Value Engineering Study &  
Constructability Review

***US 127 ALBANY BYPASS***  
***CLINTON COUNTY, KENTUCKY***  
***ITEM NUMBER 8-260.02 & 8-260.10***  
***VE STUDY NUMBER 201103***

**Final Report**

URS conducted a Value Engineering (VE) study and Constructability Review of the US 127 Albany Bypass project in Clinton County, Kentucky. The item number is 8-260.02 and 8-260.10. The topic was the 95% design submission prepared by Entran and HMB for the Kentucky Transportation Cabinet (KYTC).

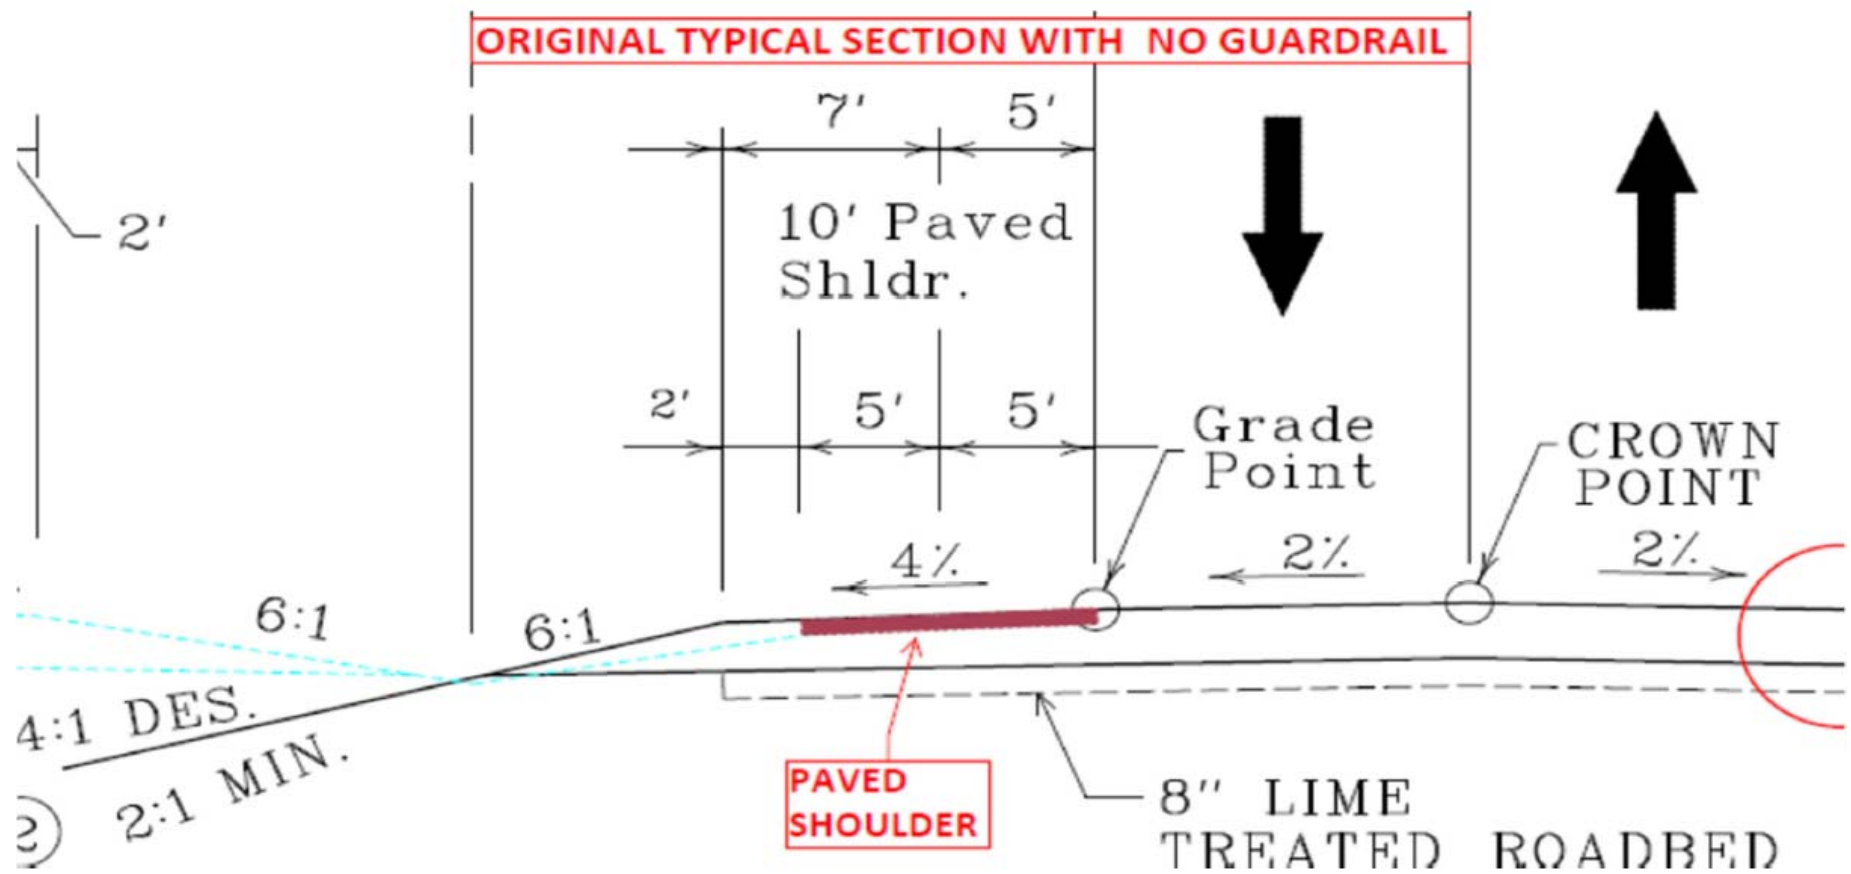
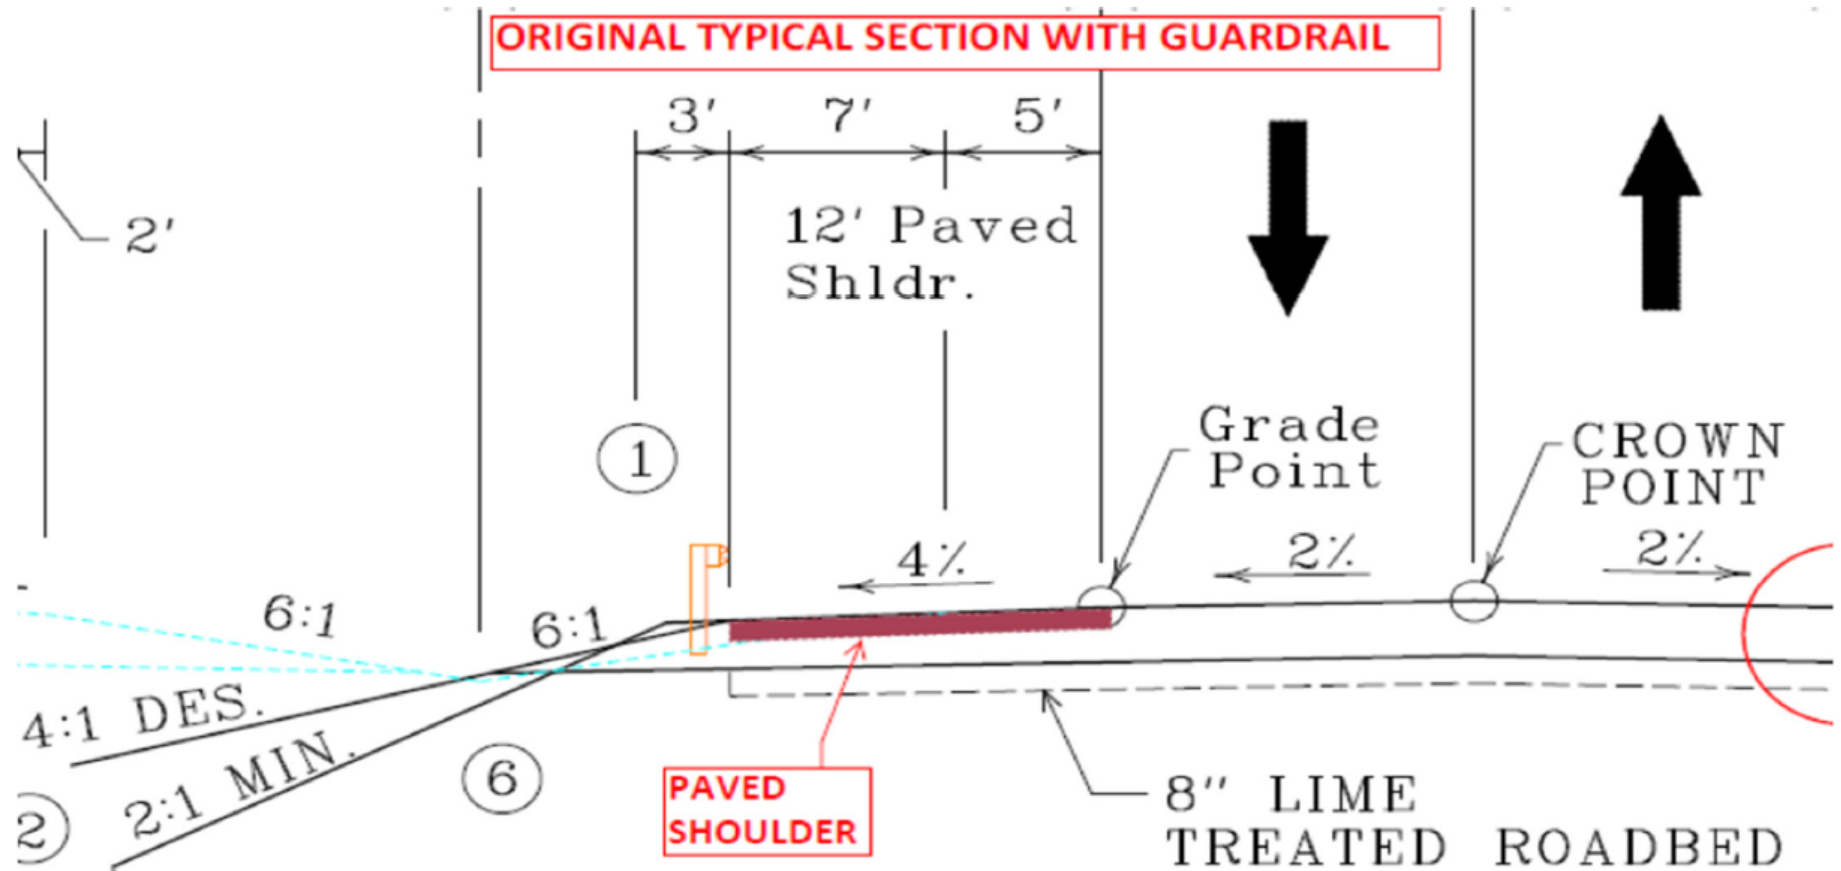
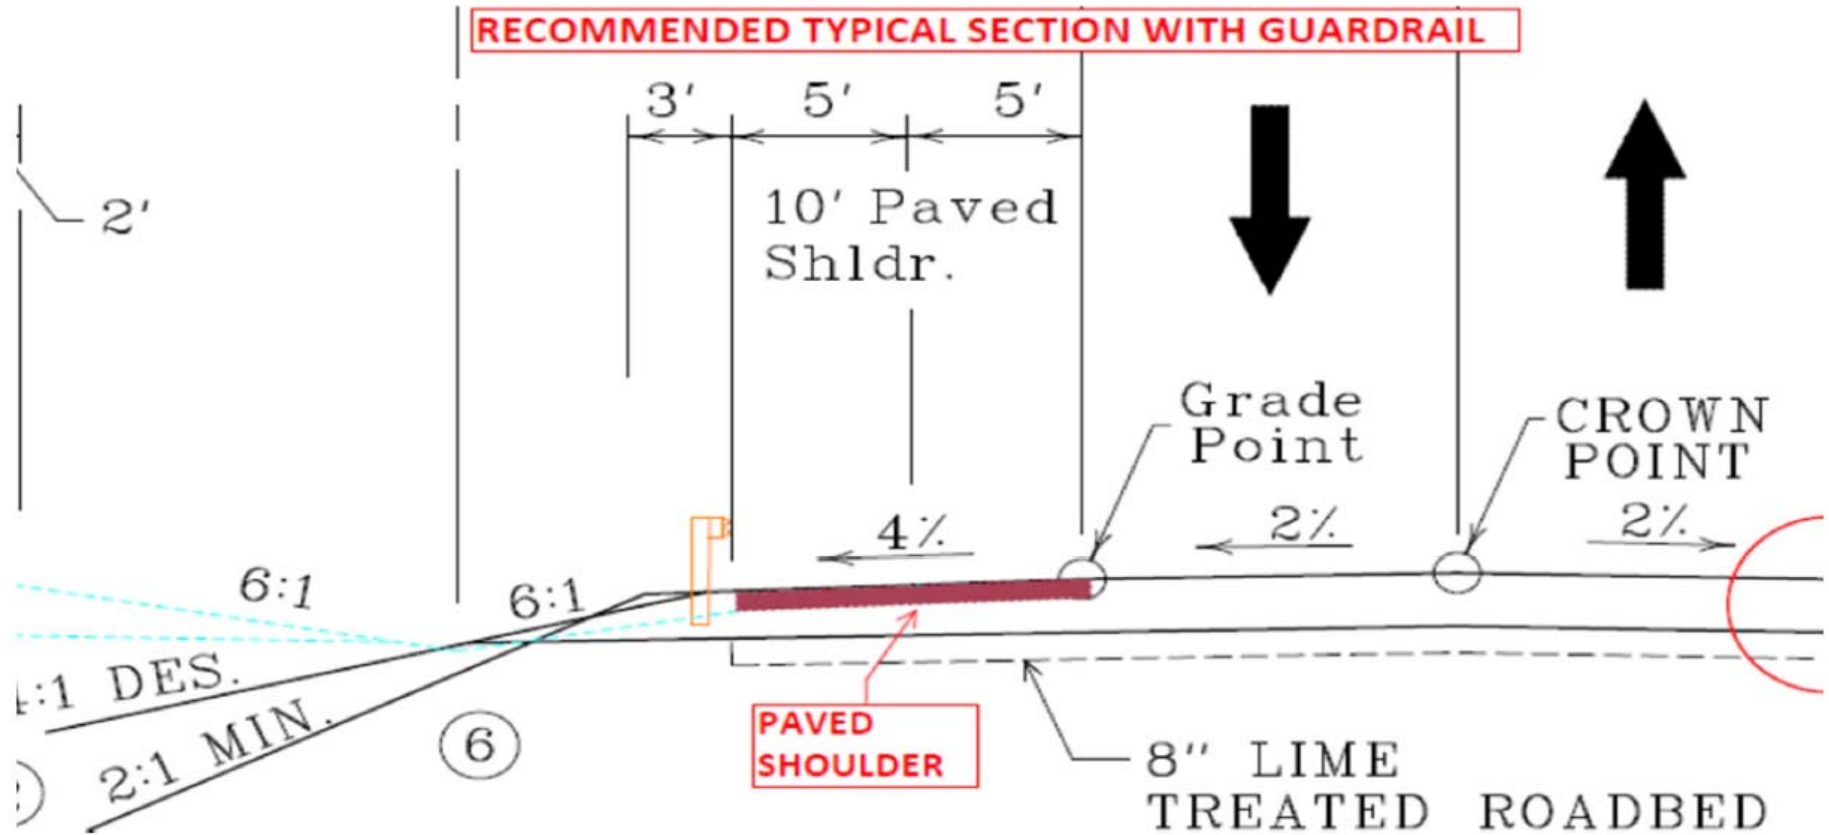
This change would eliminate 2 feet width of shoulder paving for approximately 23,455 linear feet of shoulder. The paved portion of shoulder would remain constant throughout project and would still provide for an effective 10 feet of width for emergency pullovers or farm vehicle traffic.

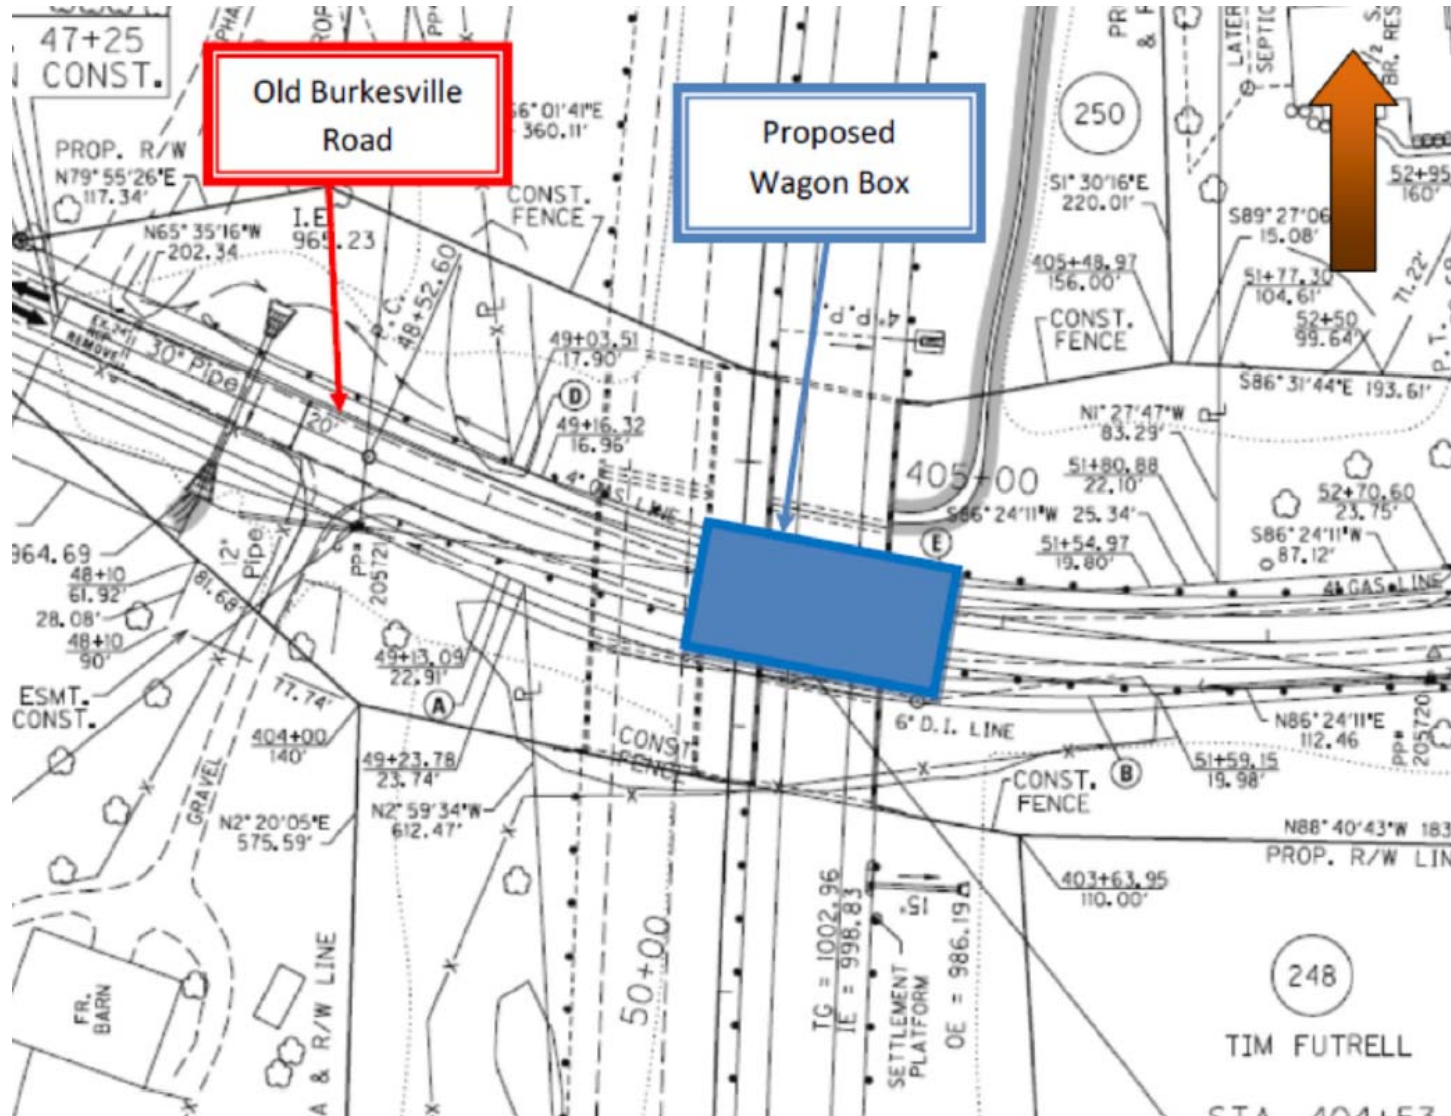
- Roadway is not in a tangent section (currently in a curve)
- More difficult to construct

The existing and proposed horizontal alignment of Old Burkesville Road is in a horizontal curve under the proposed US 127 mainline. The minimum vertical clearance from low beam for this roadway class can be 14.5 feet per KYTC design manual (HD-903). Old Burkesville Road is currently proposed to achieve a vertical clearance to low beam at 16’-10”. The proposed profile of Old Burkesville Road can be raised to achieve a smaller vertical clearance which may also potentially save on other construction items such as but not limited to earthwork, guardrail, drainage features, etc. Please note these items are not included in the value engineering estimate but only major items (structures). In order to eliminate the horizontal curve and construct a tangent wagon box, the design team may want to consider flattening the curve or revising the horizontal alignment to achieve a tangent section if constructing the box in a curve is an issue. The proposed right of way in this area is very wide and this option should be further coordinated with the project team. Utilizing the wagon box in lieu of the bridge will achieve a construction savings and still provide continual access for residents on both sides of the wagon box.
